**IC CORPORATION**  
751 SOUTH HARKRIDER, CONWAY, AR 72032

**ADDENDUM # 2 TO IC CORPORATION RECALL # 03306**  
**NHTSA RECALL # 04V-010**

**REF: Modesty Panel at Front Barriers**

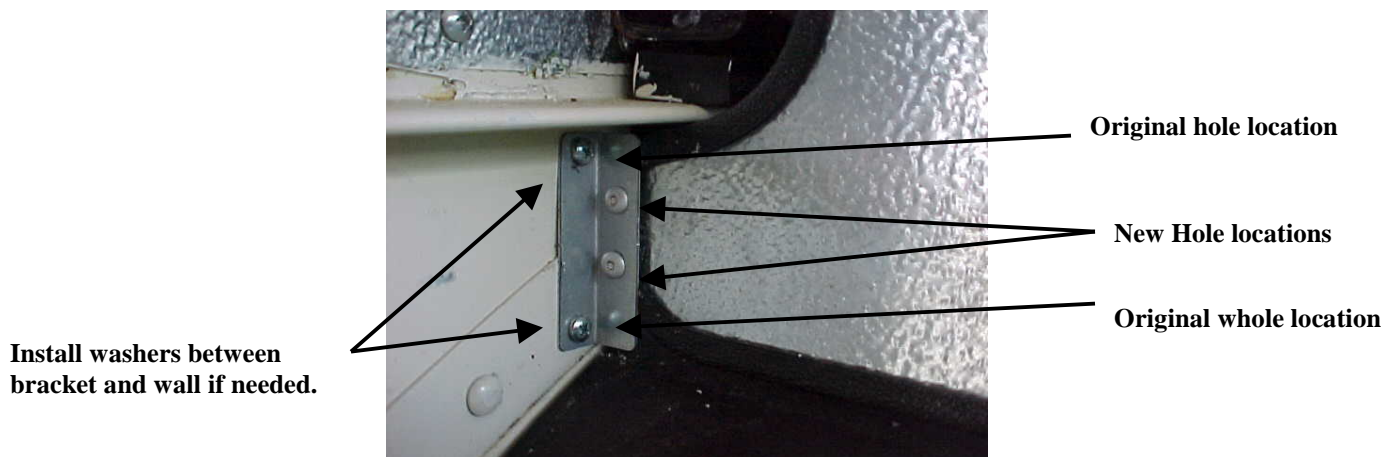
The original recall letter omitted the repair method with a special condition on the right side (entrance door side) modesty panel. The modesty panel at the wall sometimes is too short in height where it attaches to the new bracket at the wall. The two guide holes do not line-up with the panel and therefore you cannot attach the panel to the bracket. If the modesty panel at this area is not long enough in height to match the repair bracket predrilled guide holes, drilling one or two 1/8-inch diameter hole(s) closer to the center of the bracket and through the modesty panel to rivet the two parts together is permissible. The function of the bracket is to prevent the modesty panel from being kicked out of position and the closer location or one fastener will provide this function. Also the location of the existing rivets on the wall in the area varies and may interfere with the installation of the bracket in the desired position. Putting large diameter flat washers with a 3/16" to 1/4" inch hole as a spacer between the supplied bracket and the wall will move the bracket away from the existing rivet and provide an approved installation. The picture below shows the method of installing this bracket with the two rivets closer to the center of the bracket. If snake rubber is on the panels in the area it does not have to be trimmed back to clear the bracket. The rivet when installed will pull the panel as tight as needed.

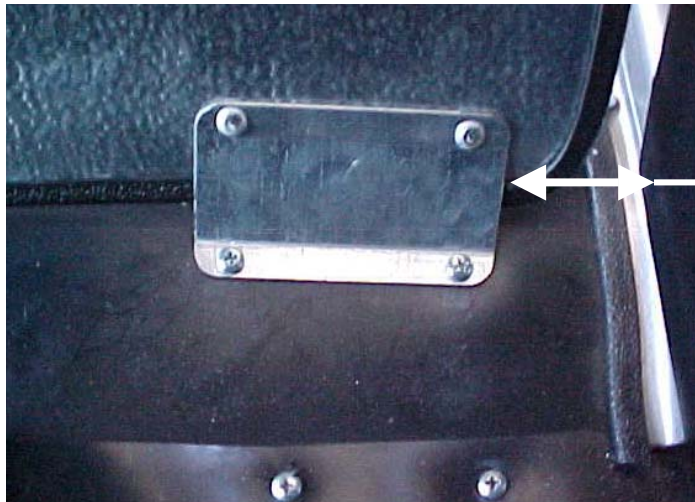
The original recall letter omitted the repair method and parts for a combination of the left modesty panel and drivers under seat heater, code 048PLX. The bracket supplied with the kit for this combination will not provide the proper repair and should not be used. In place of the bracket supplied with the kit, a new bracket part number 2209386C1 must be used. It mounts in a different location using the same size mounting hardware supplied with the kit and same size drill. When ordering a kit for units with this combination the new bracket must also be ordered. The picture below shows the proper method of installing this new bracket. This does not affect the repair of the right side modesty panel.

Position the bracket approximately 1.5 inches from the vertical face of the heater cover with the greater angle (about 45 degrees) attached to the modesty panel. For ease of installation, attach the bracket to the floor first with the upper portion in line with the modesty panel.

Area where  
panel may be  
bent out of  
position.

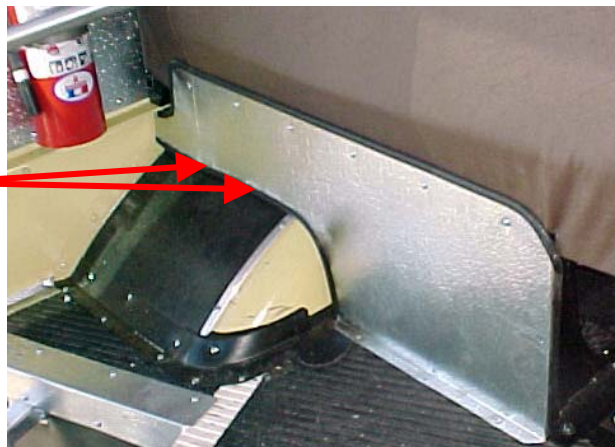
The steel modesty panel that is installed under the seat barrier behind the driver seat and behind the entrance door is cutout to clear the wheel well. This cutout allows the lower portion of the panel to be bent out of position leaving a gap between the wheel-well and the lower edge of the modesty panel at the cutout area. The edge of the cut out is protected with snake rubber (protective edging). If the snake rubber is knocked off of the edge of the panel, a raw edge is exposed facing down.

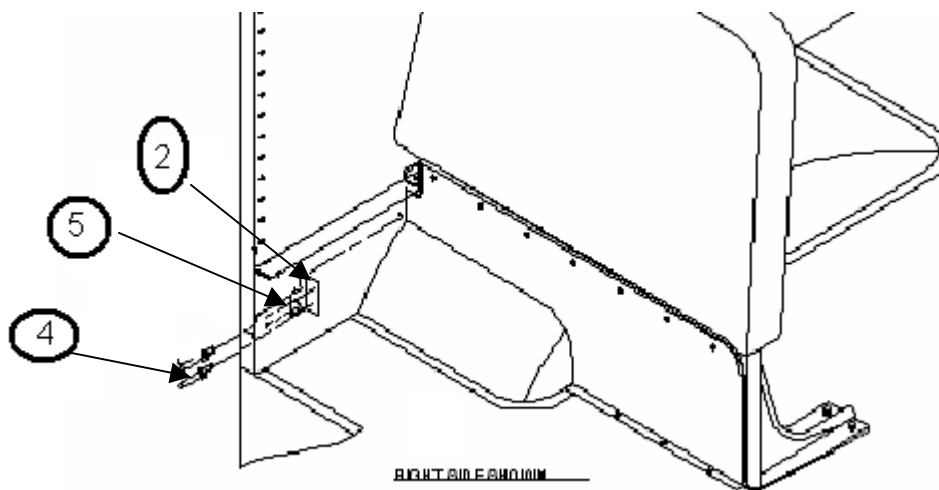
This repair procedure involves adding a bracket at the wall to secure the end of the modesty panel. This must be done to the panel on both sides of the bus.

1. Locate the angle (item #2) centered vertically with the end of the panel.
2. Install angle onto wall with two self-drilling screws (item #5).
3. Using a 1/8-inch drill bit, drill two holes through the angle and modesty panel.
4. Fasten angle to modesty panel with two (2) of item #4 –(rivet, pop 1/8")
